CHANGED 44R02-4111-150 TO 44R02-4111-250. (RFB)			
1	9250	12/31/97	RE
REV	ECN	DATE	APV
THIS PRINT IS THE PROPERTY OF ITS CORP. IT SHALL NOT BE COPIED WITHOUT PERMISSION.			
MATERIAL		TITLE	
---		AC DISTRIBUTION ASSY, EXC. CAB. (1245-1500)	
FINISH		DWG. NO.	
---		1245-8500 1	
REV		SCALE 1=1	
ECN		SHEET 1 OF 1	
DATE		REV	
APV		1	
DWN		5/28/98	
CHK		5/28/98	
REL		5/29/98

TITLE I/C AC DISTRIBUTION
ASSEMBLY, (SINGLE PHASE)
(1278-1200)

DWN	TMY	12/11/96	DWG. NO.	REV
CHK	RE	12/13/96	1278-8200	2
REL	RE	12/13/96	B	SCALE---

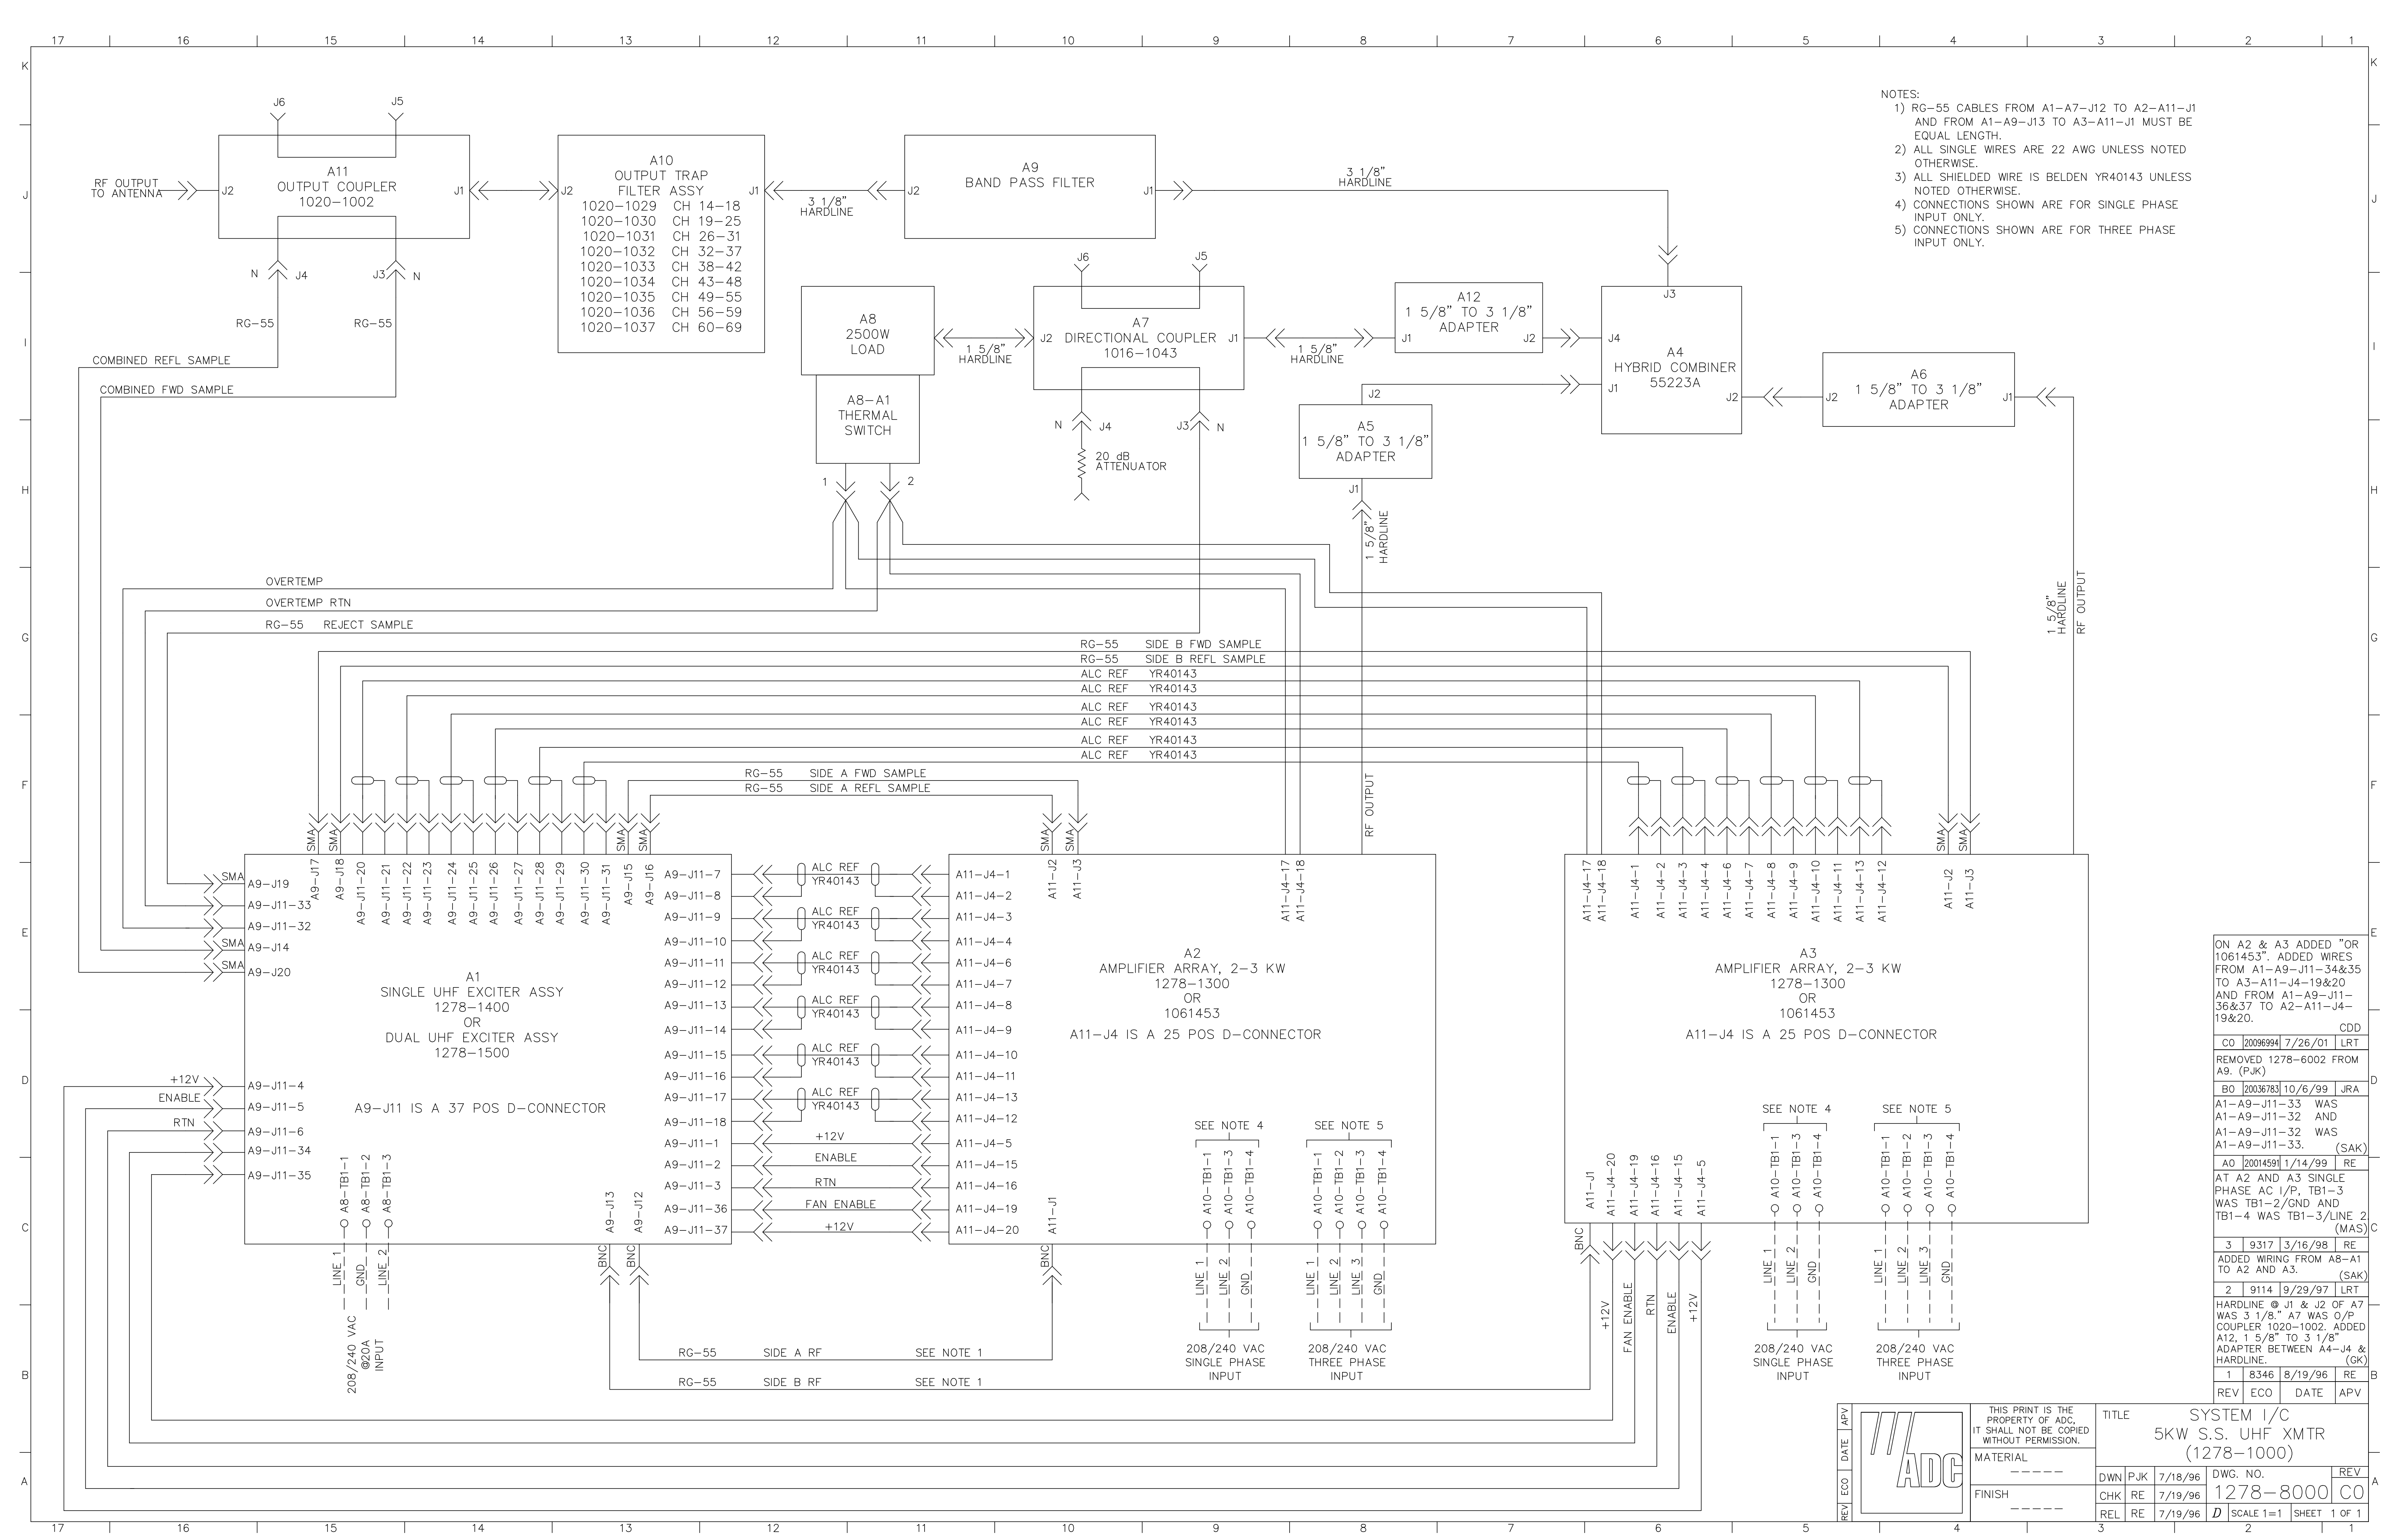
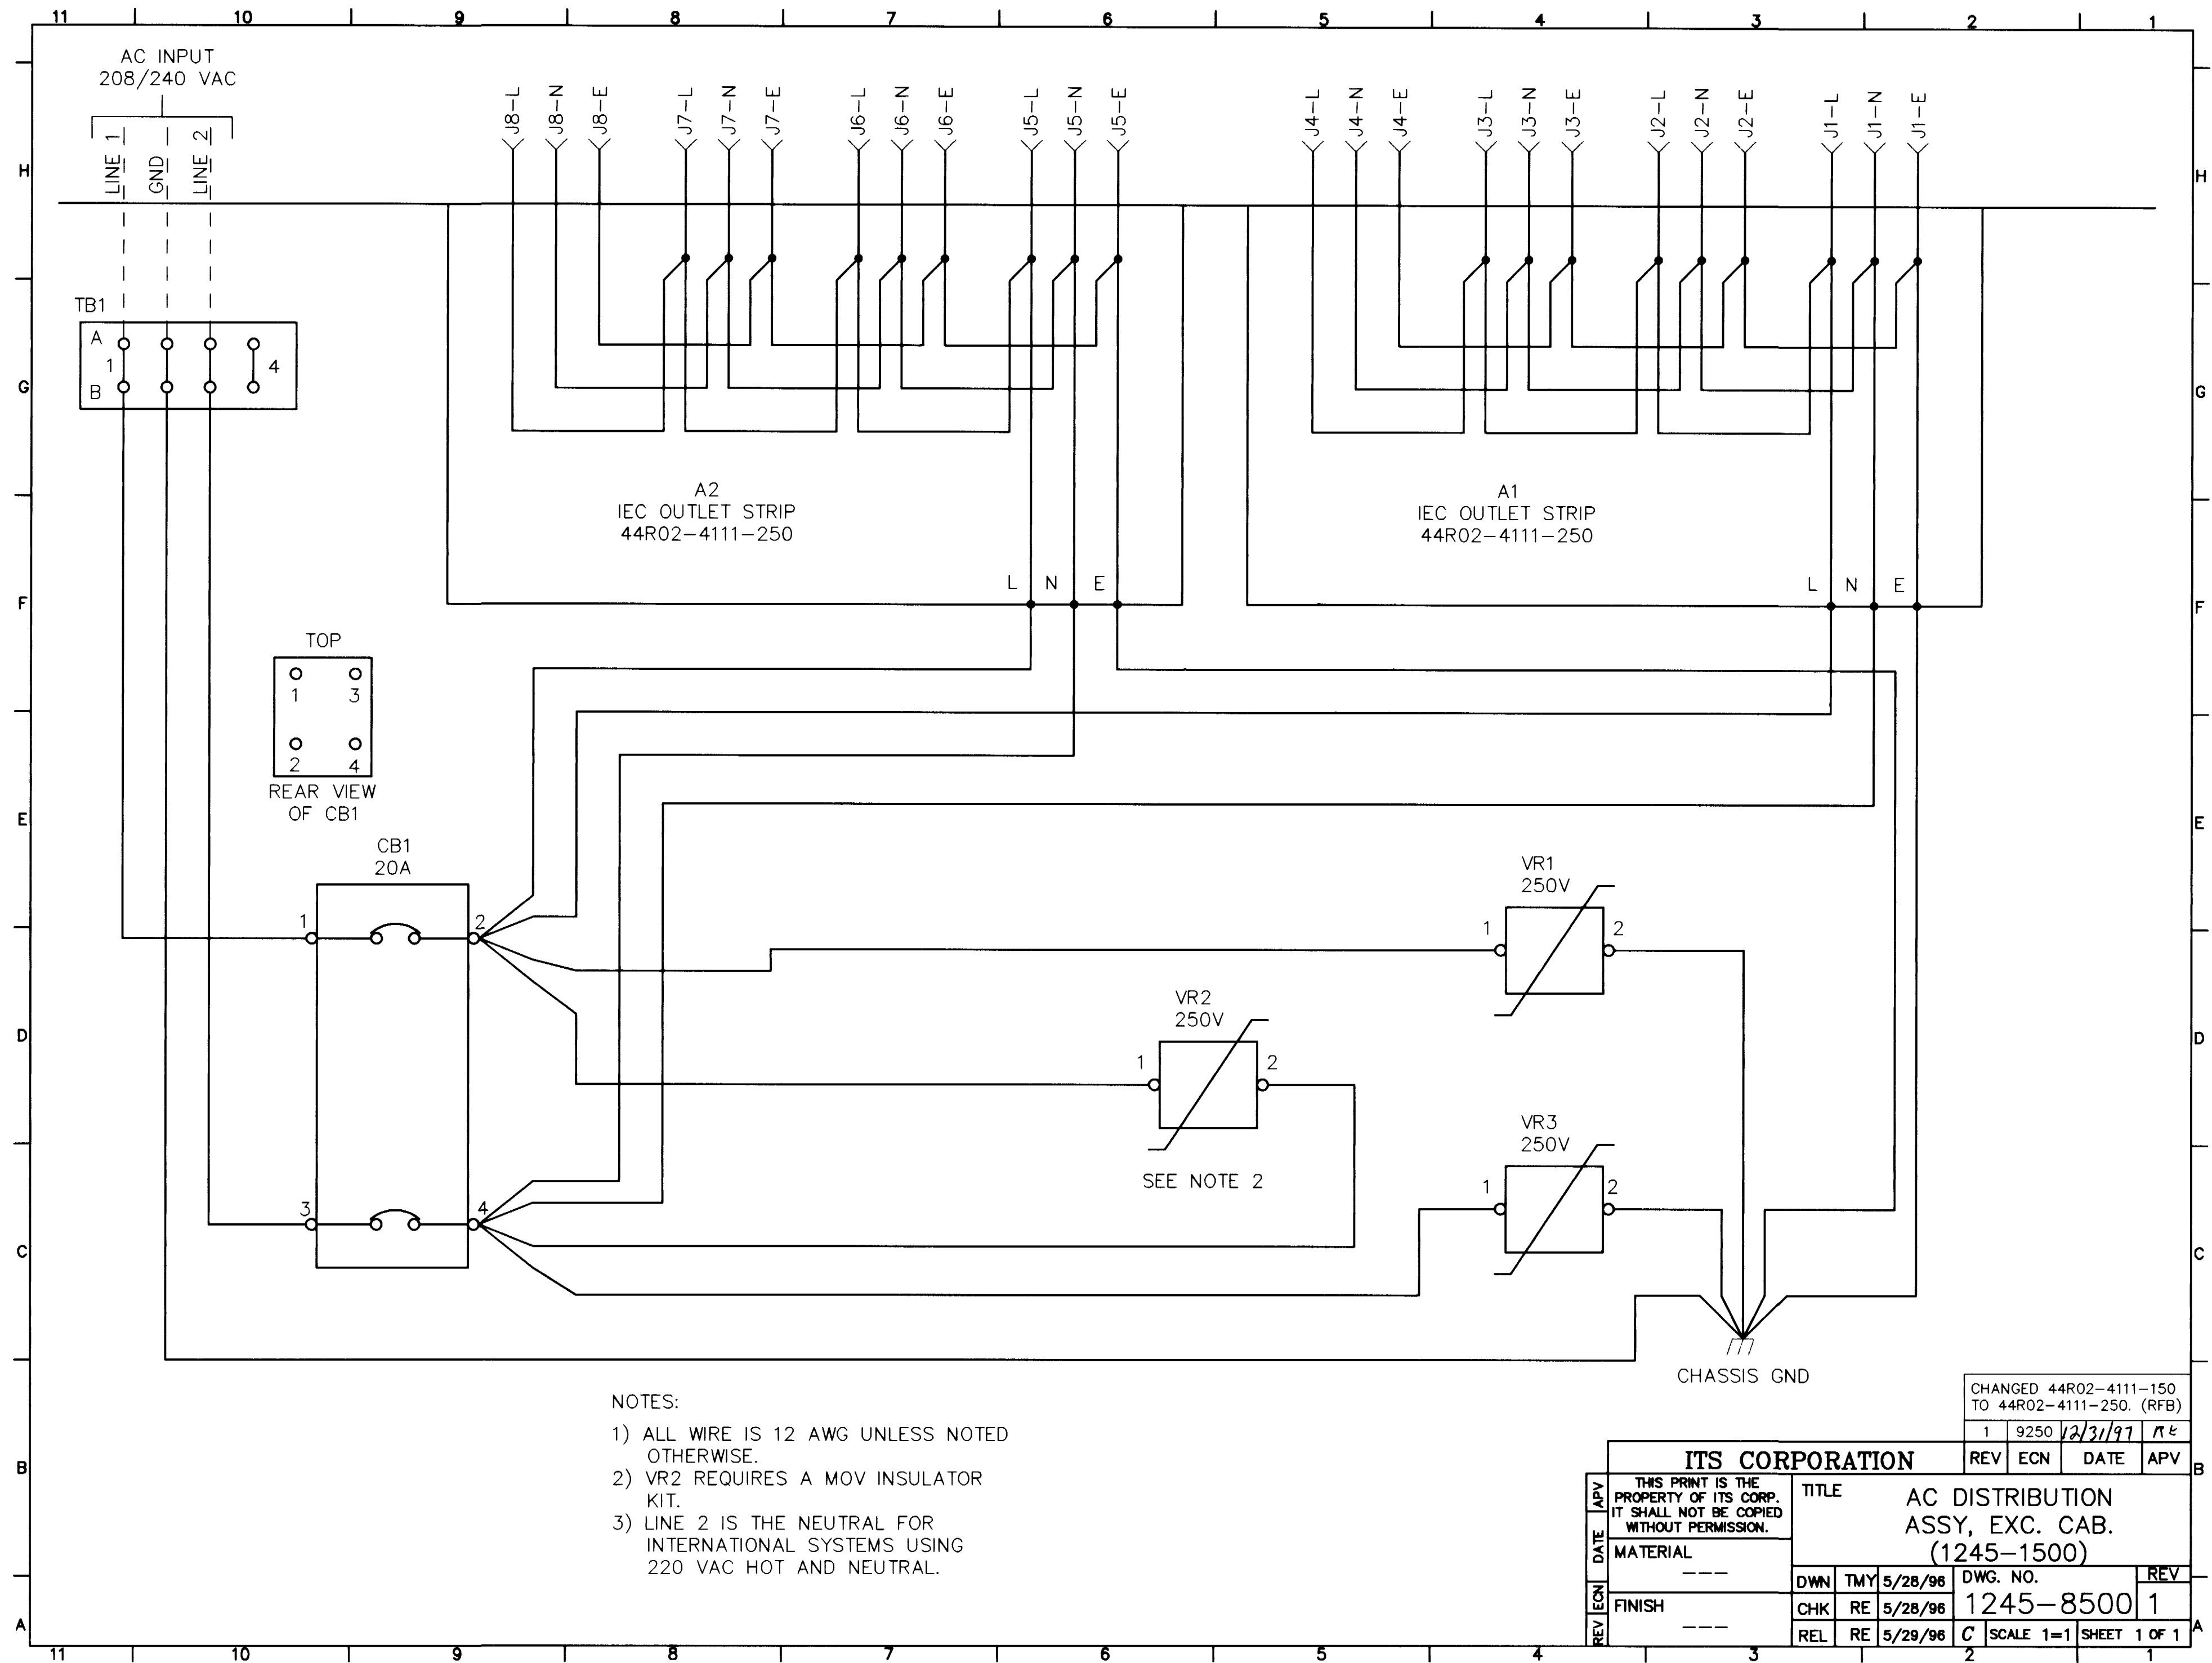
ADDED 2 AWG WIRE AT
CB1-6 & CB1-2.
SECONDARY OF CB1 WAS
CONNECTED TO BUS BAR.
MOVED CB8 & CB9 TO
ELIMINATE 4 WAY CONN.
AT VR3 & VR4. (MAS)

ADDED CB8 & CB9 AS
SHOWN USING 18 AWG
WIRE. (MAS)
